Project	IEEE 802.16 Broadband Wireless Access Working Group < http://ieee802.org/16 >	
Title	Modification of Open loop STC	
Date Submitted	2004-3-09	
Source(s)	Chan-Byoung Chae, Wonil Roh, Sung-Ryul Yun, Kyunbyoung Ko, Hongsil Jeong, JeongTae Oh, Seungjoo Maeng, Panyuh Joo, Jaeho Jeon, Jerry Kim, Soonyoung Yoon, K. Sivanesan, Marcos Katz, DS Park	cb.chae@samsung.com
	Samsung Electronics Co., Ltd.	
	Jianzhong (Charlie) Zhang, Anthony Reid, Kiran Kuchi, Heikki Berg, Nico Van Waes	Charlie.Zhang@nokia.com
	Nokia Research Center	
Re:		
Abstract	Modification of the open loop STC for 3, 4 Tx	
Purpose	Adoption of proposed changes into P802.16e	
	Crossed out indicates deleted text , <u>underlined blue indicates new text change to the Standard</u>	
Notice	This document has been prepared to assist IEEE 802.16. It is offered as a basis for discussion and is not binding on the contributing individual(s) or organization(s). The material in this document is subject to change in form and content after further study. The contributor(s) reserve(s) the right to add, amend or withdraw material contained herein.

Modification of Open loop STC

Fig 1. An example of the choice of subscript k to determine the Matrix A.

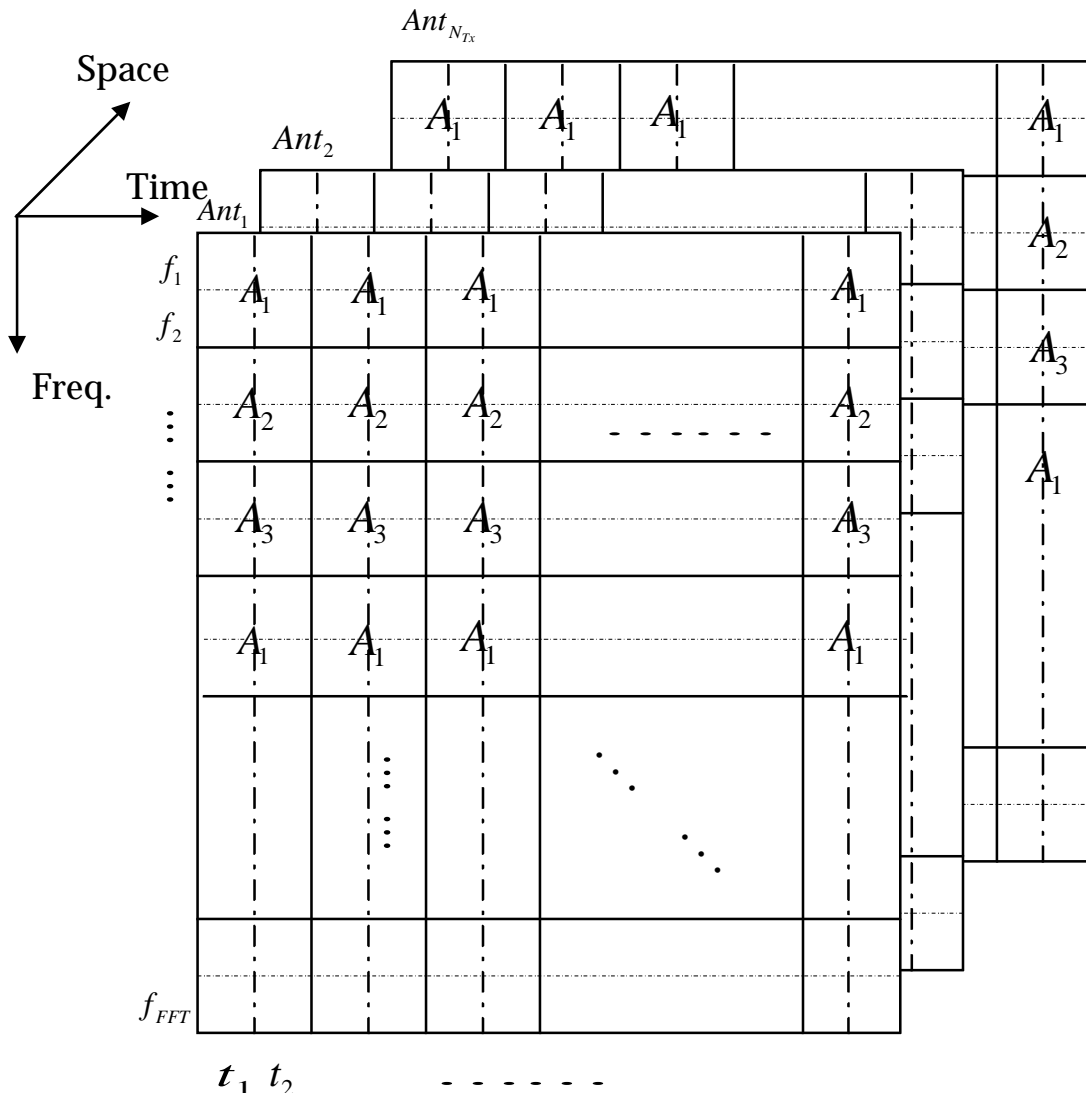
Since, there are space-time-frequency codes (over two OFDMA symbols and two sub-carriers) in [1], we propose a modification of the 3 Tx antenna STC for rate 1 and 2, i.e., Matrix A, Matrix B, should be changed to:

$$k = \text{mod}(\text{floor}(((\text{logical_data_sub_carrier_number_for_first_tone_of_code} - 1) / 2), 3) + 1$$

In addition, the above equation can be applied to the 4Tx antenna rate 1 (Matrix A).

where, logical_data_sub-carrier_number_for_first_tone_of_code = 1, 2, 3, ..., total number of data subcarriers.

~~In optional FUSC zones, †The index k , of permuted version of Matrix A and B to use for a particular deployment is given by : $k = \text{mod}(\text{logical_data_sub_carrier_number_for_first_tone_of_code}, 3) + 1$~~ $k = \text{mod}(\text{floor}(\text{logical_data_sub_carrier_number_for_first_tone_of_code} - 1)/2), 3) + 1$, where $\text{logical_data_sub_carrier_number_for_first_tone_of_code} = 1, 2, 3, \dots$, Total # of data sub-carriers.

$$k = \text{mod}(\text{floor}(\text{logical_data_sub_carrier_number_for_first_tone_of_code} - 1)/2), 3) + 1$$
